CERTIFICATE OF APPROPRIATENESS PLACARD

Install solar panels

Pilot-Crompton Mill

COA-0128-2020

SP1.0m

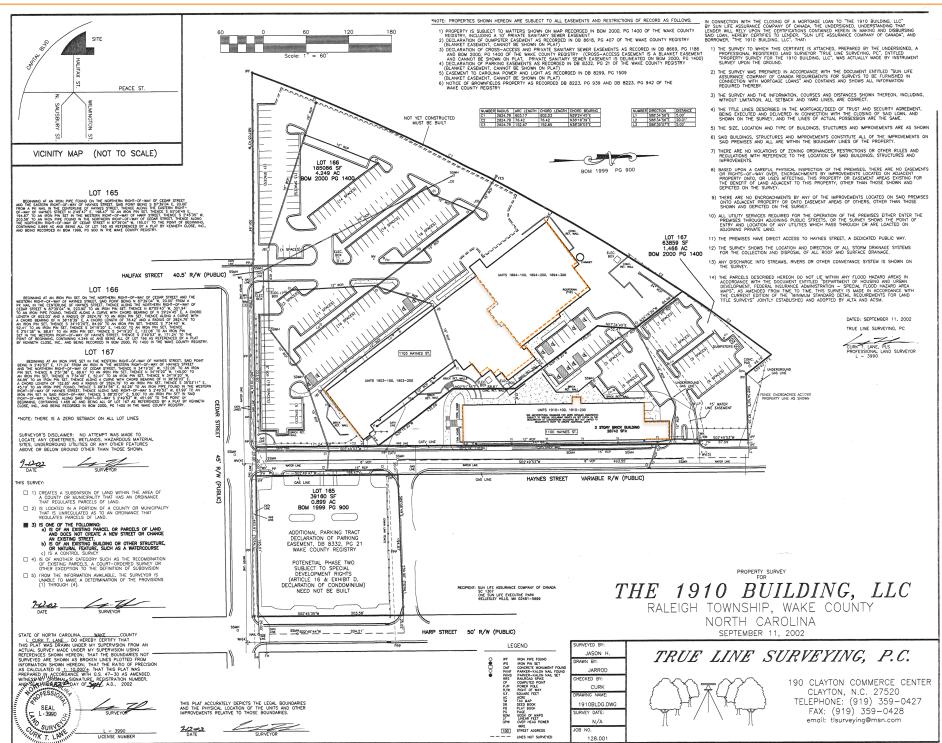
The previously requested information of a full site plan for context and a roof plan identifying the areas where roof parapets or other edging materials sit higher than the finished roof surface, and how high above the roof surface they rise, would also be tremendously helpful. Please send the photographs and any additional materials at your earliest convenience. Thank you.

Some additional items that would be required in order consider the application complete are a scaled site plan, showing the two buildings to receive solar panels in context with the full site. Please also provide several contextual photographs of the buildings from all angles, including the adjacent streets and parking lots. On the diagram provided, it would be helpful to note the location of any parapets and their height from the roof surface.

- 1. A site plan showing the locations on the roof where there are parapet walls on both buildings.
- 2. A old landscaping plan.
- 3. The brochure showing the racking system. It is a system that is held down by ballast (shallow cinder blocks). The system is designed to sit on the roof without penetrating the building more than a few times. I have spoken to the panel provider and the height of the racking system + panel at its highest point is 9.5", and at its lowest point, it is 3.4".
- 4. All of the other equipment shown on the plans I originally sent is existing HVAC equipment.

1894 and 1903 Buildings

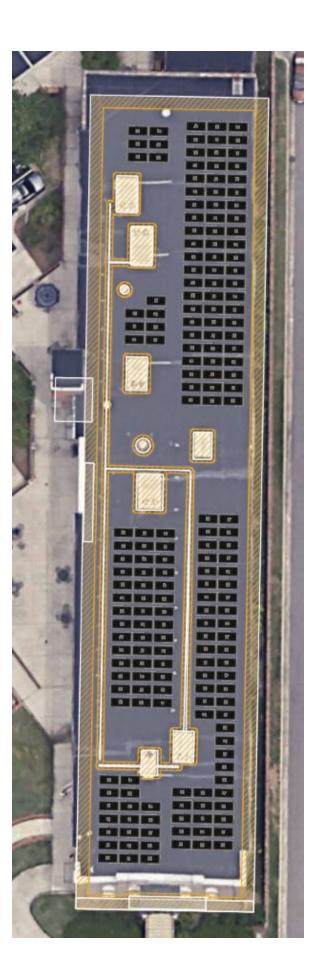
Solar Panels are not visible on this section of roof.

Panels are just slightly visible above the roof line along this elevation. It looks like 3-3.5 inches could be visible above the roofline depending on the viewer's vantage point.

1910 Building:

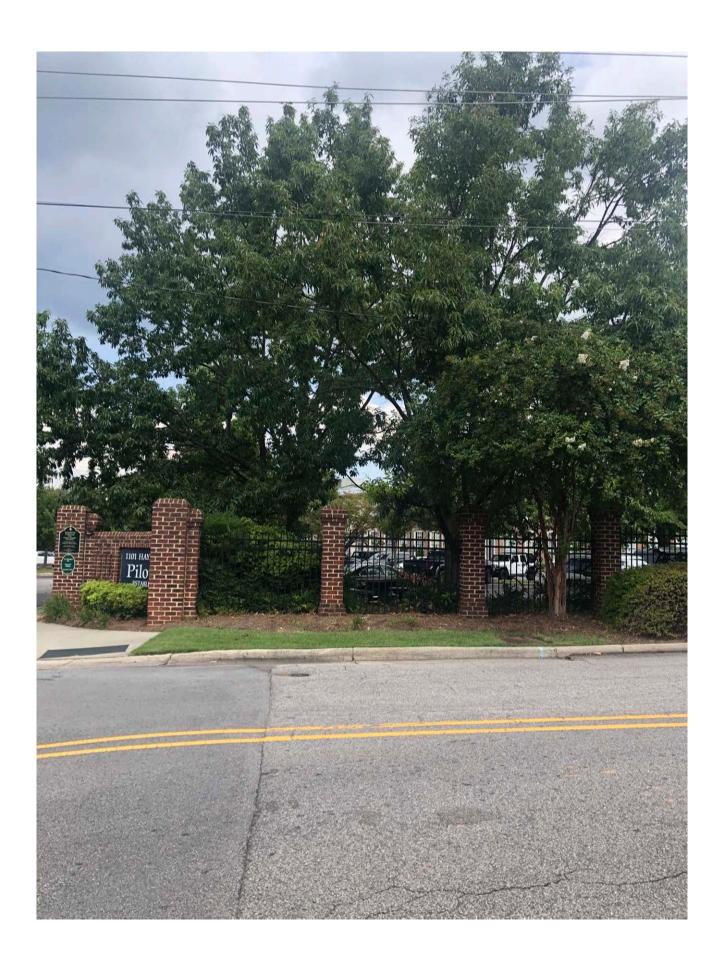
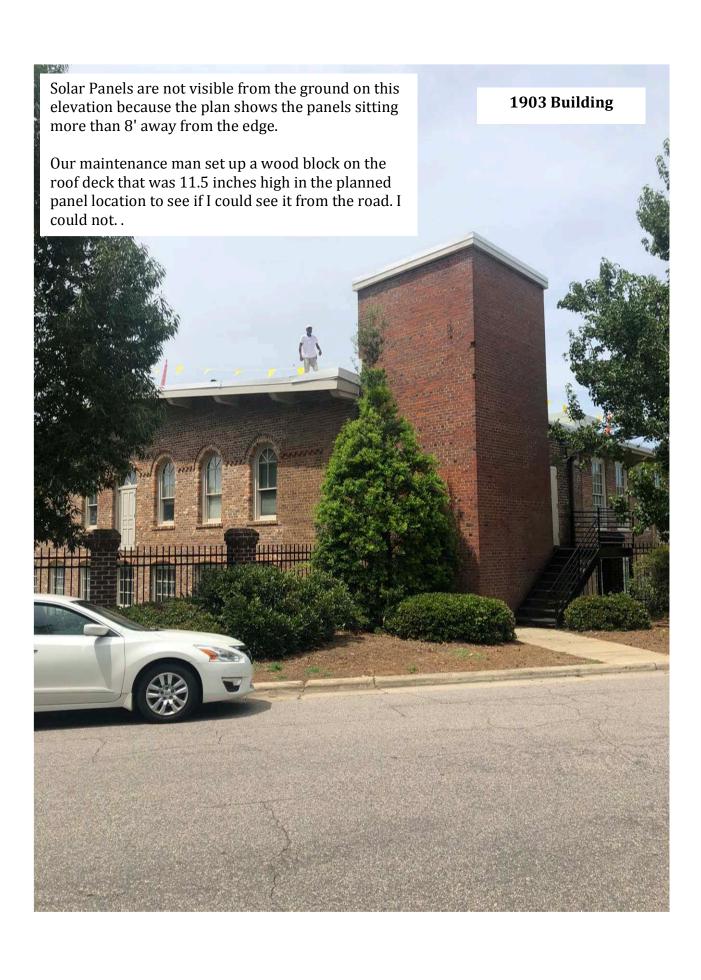
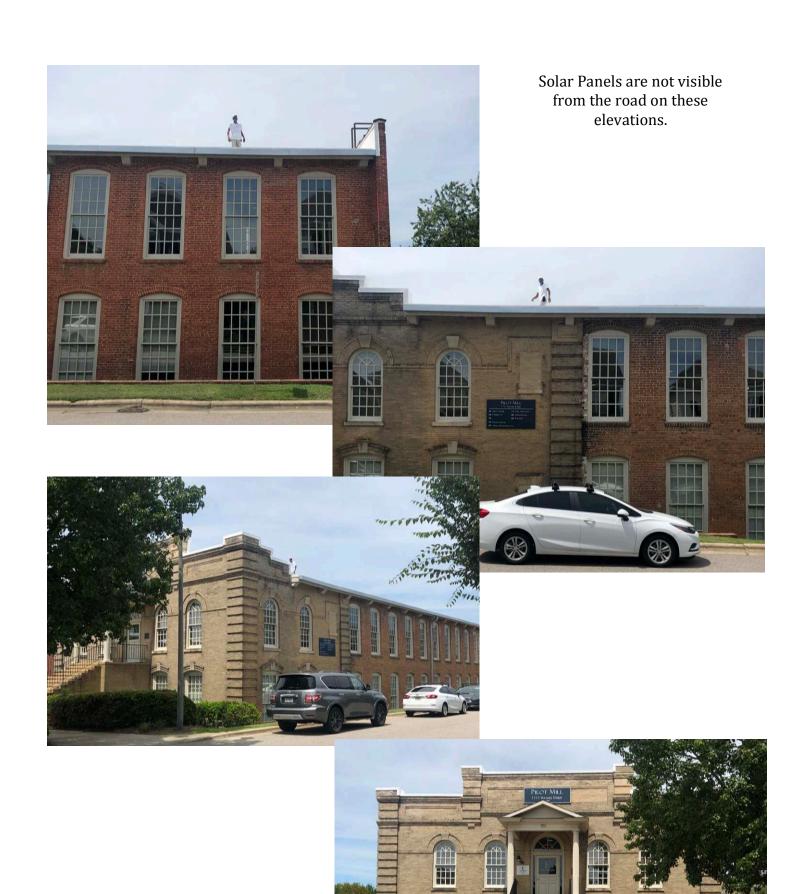
Solar Panels are just slightly visible above the roofline along this elevation. Possibly 3-3.5" could be visible above the roofline.

Solar Panels are not visible above the roof line on this building.

1903 Building

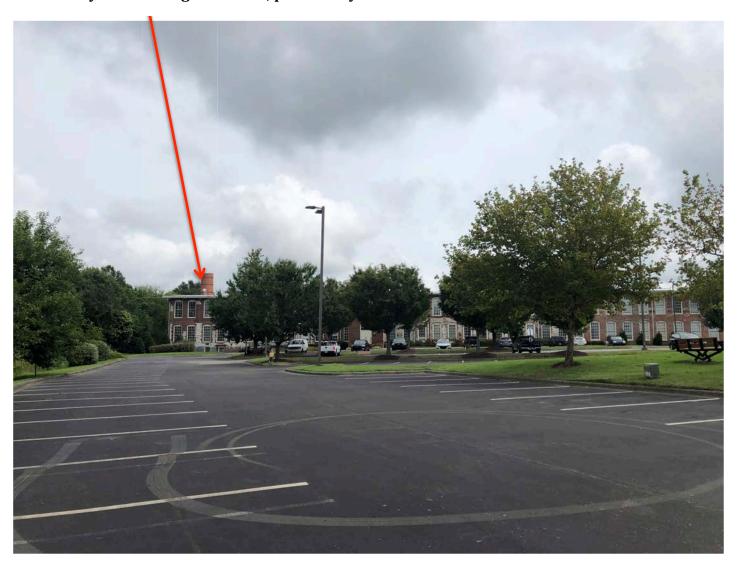
Handyman holding 9.5" block, panel not visible

Handyman holding 9.5" block, panels may be \sim 3 inches visible

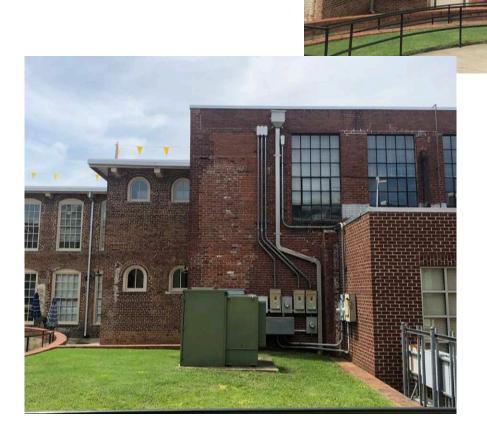
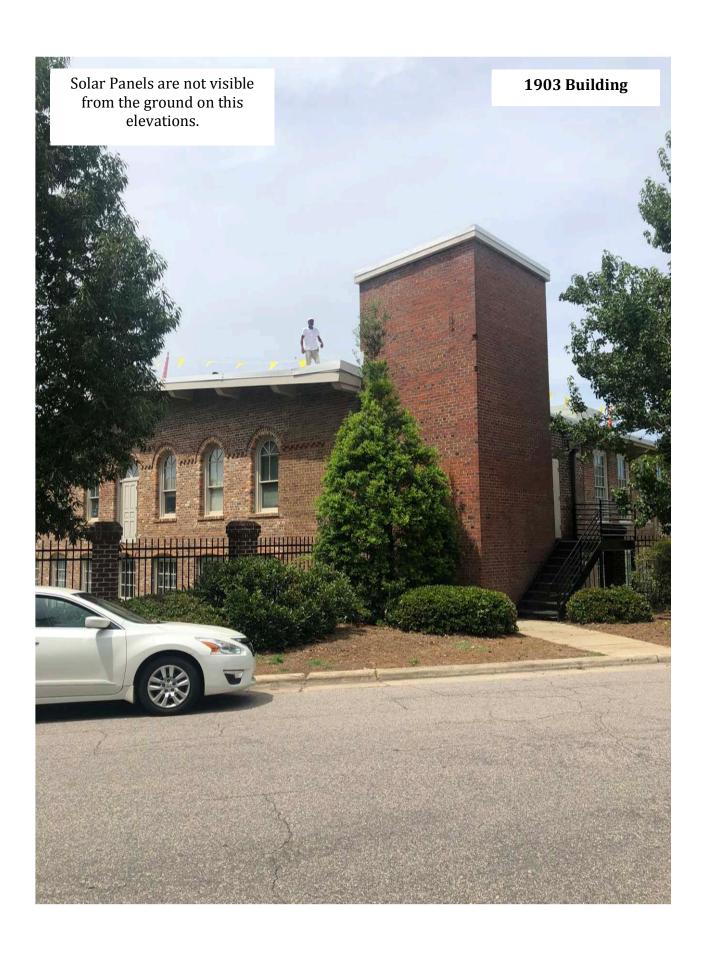
Solar Panels are not visible from the ground on these elevations.

Solar Panels are not visible from the ground on these elevations.
